SUBJECT: Changes in PD Unit Of The TR-7400A

DATE 1-19-79

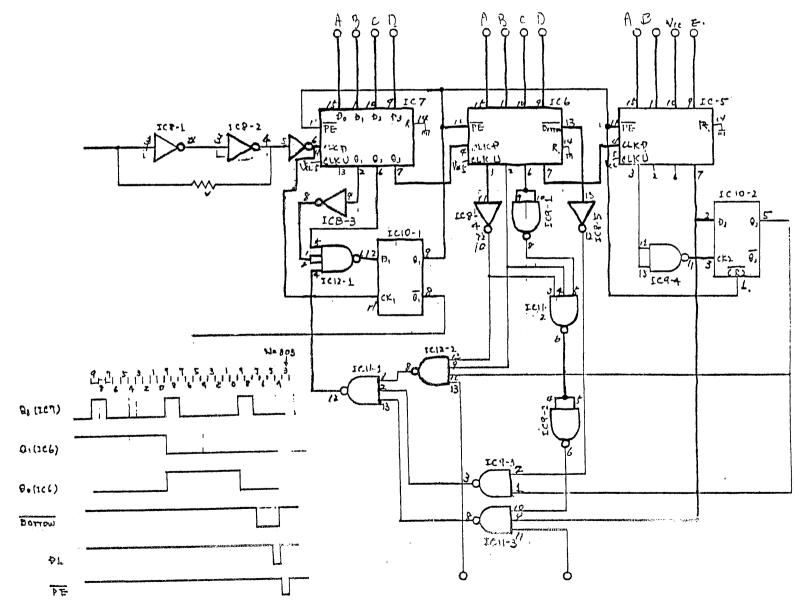
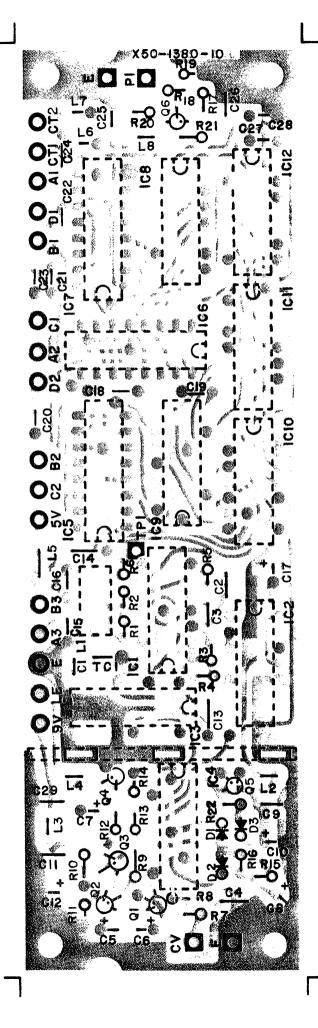
There was a temporary production change in the PD Unit of the TR-7400A. This change effected the 73XXXX and 74XXXX series units only. The change was made because of the Motorola MC-4016P IC was not available. The Texas Instruments' SN74LS192 IC was used as a replacement. It is not a direct replacement, though. It was also necessary to change IC-8 from a TD-3400AP to a TD3404. This series of PD Units is easily recognized because of the three SN74LS192 IC's are mounted in sockest instead of being soldered in place. The PC board was changed to J25-2512-03T instead of J25-2512-03 for this change. The schematic is shown below.
